FINAL PLAT OF
"DEER CREEK ESTATES
SECOND ADDITION"
SEDGWICK COUNTY, KANSAS
(SW1/4 OF SEC. 24, T28S, R1W OF THE 6TH P.M.)

S/D 98-21 - Final Plat of VANDERHOFF ESTATES

At the regular meeting of the Subdivision Committee of the Metropolitan Area Planning Commission on Thursday, August 20, 1998, the above captioned plat was considered. The action of the Committee was to approve the final plat, subject to the following:

CASE NUMBER: S/D 98-21 - VANDERHOFF ESTATES

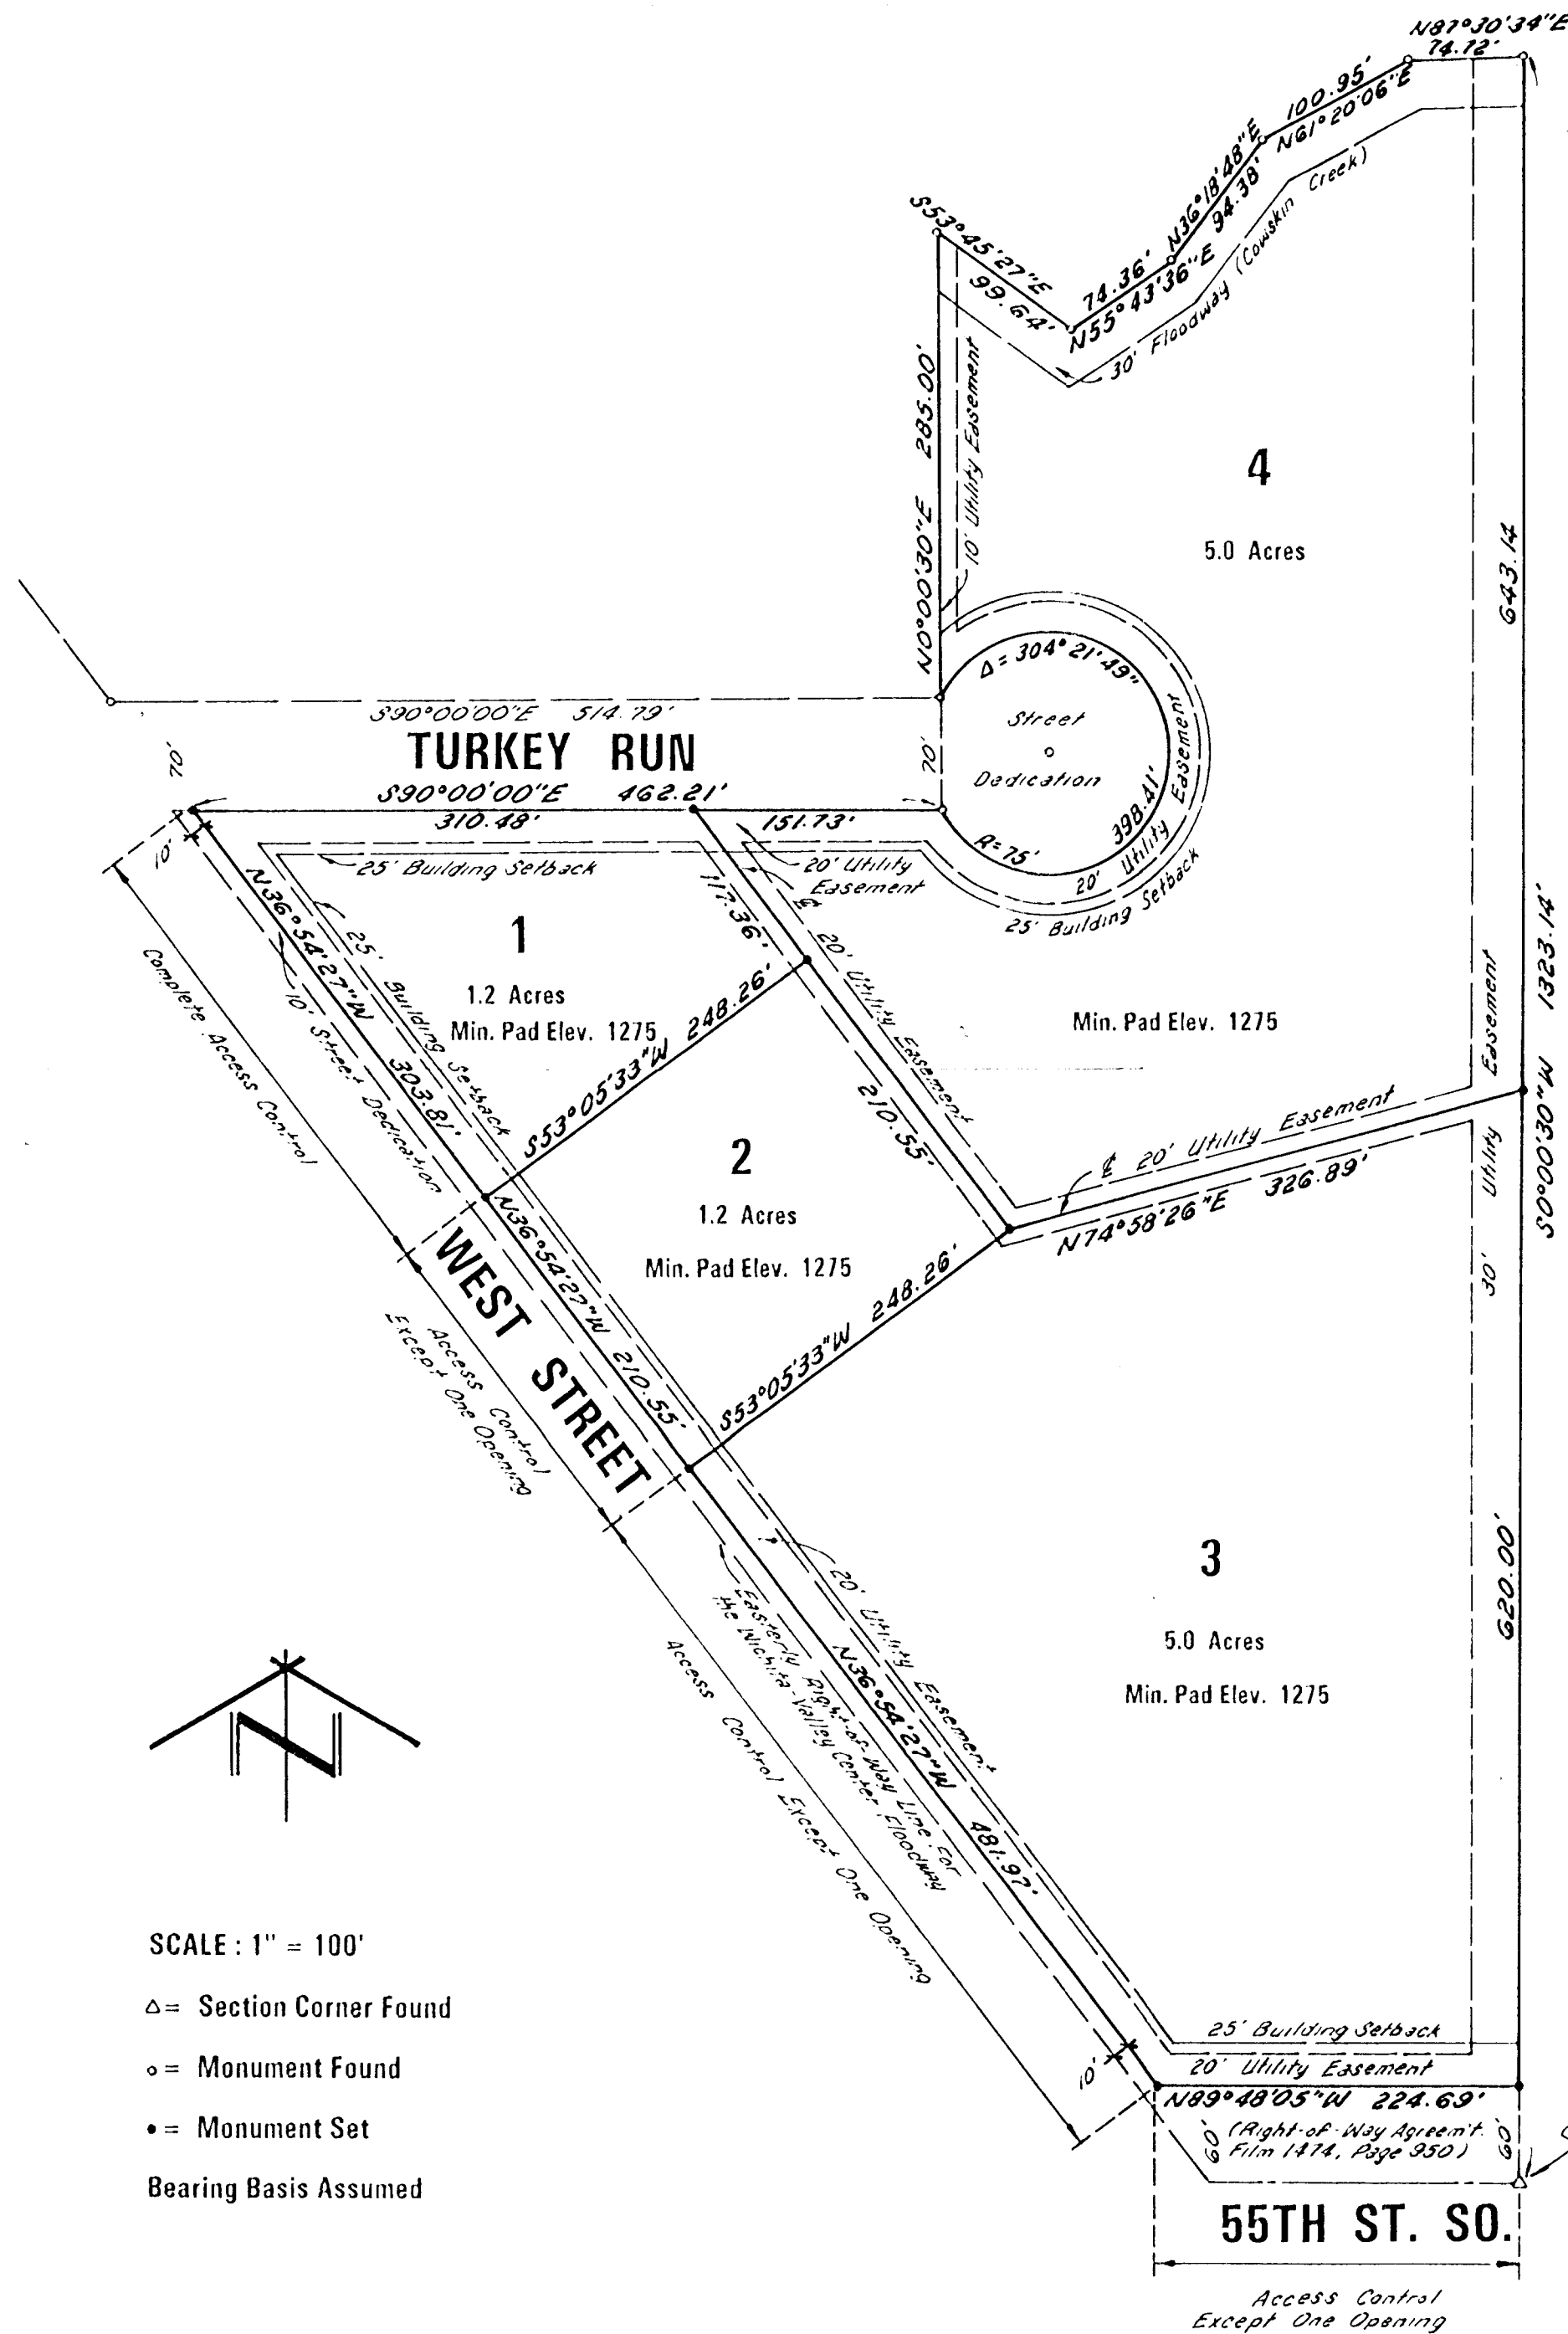
- C. City Engineering needs to indicate the status of Wichita water and sanitary sewer service for this area and what guarantees need to be provided at this time. *Guarantees will be required for future City water and sanitary sewer. An easement for future location of sanitary sewer needs to be denoted on plat.*

- E. County Engineering needs to comment on the status of the applicant's drainage plan. The drainage plan has been approved.
- F. County Engineering and MAPD recommends dedication of access control along West Street except for one opening each for lots 2 and 3. Access to Lot 1 shall be from Turkey Run. Subdivision Committee approves said openings in addition to an opening from Lot 3 to 55th Street South per applicant's desire to maintain an existing opening.

- H. It is recommended that the front yard utility easements are eliminated and replaced with rear yard utility easements. Overly wide utility easements (30 foot) are recommended to be platted in the rear of lots 3 and 4 to allow for the installation of utilities without damage to existing tree rows. Subdivision Committee approved both front and rear yard easements to give developer an option of their location.

The requested access controls have been denoted on the final plat.

The final plat denotes the requested 30-foot easement in the rear of lots 3 and 4.
